[Docket No. 98-SW-74-AD; Amendment 39-11807; AD 2000-13-08]

Airworthiness Directives; Eurocopter Deutschland GmbH Model EC 135 Helicopters

ACTION: Final rule.

Figure 1

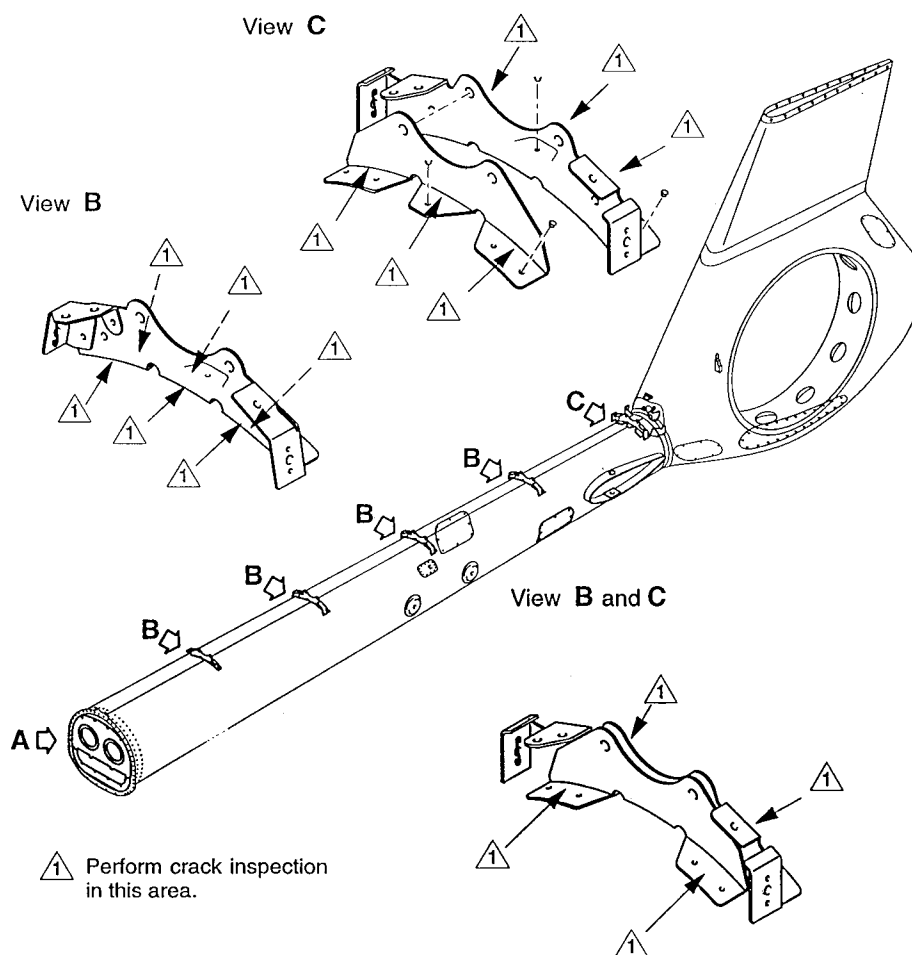
(1) Clean each tail rotor drive shaft bearing support. Using a 6-power or higher magnifying glass and a bright light, visually inspect the attach lugs of the bearing supports B and C (shown in Figure 1) for cracks, particularly in the area extending from the bend radius to the attaching screws and rivets connecting the bearing supports to the tail boom. Before further flight, replace each cracked bearing support with an airworthy bearing support.

(2) Inspect each bearing attach hardware lock plate for bent-open tabs and slippage marks for attach hardware looseness or rotation. Before further flight, replace any loose bearing attach hardware (including lock plates found bent or open due to bolt rotation) with airworthy hardware.
